Product Announcement

Improvement to OMJ **Disconnect Cut-Off Switch Added**

Manaras-Opera Standardizes the Disconnect Cut-Off Switch on OMJ

OMJ Cut-Off Disconnect Switch

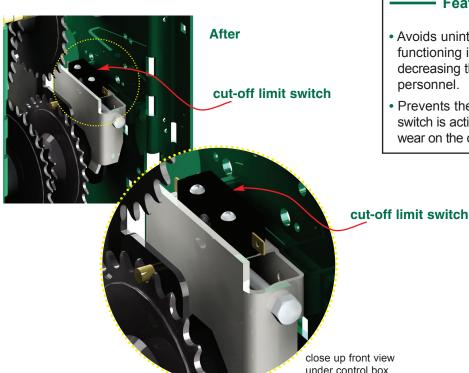
The **OMJ** series will now be supplied with a disconnect cut-off switch. The cut-off switch functions to disconnect the operator's 24V control as soon as the disconnect system is activated. During this time, open/close/radio/safety or other inputs will not energize the operator.

- Avoids unintended operation of the operator when it is functioning in the disconnect or manual modes, thus decreasing the risk of injury to the end-user or maintenance personnel.
- Prevents the operator from operating after the disconnect switch is activated, therefore reducing the risk of unintended wear on the operator components and electrical consumption.
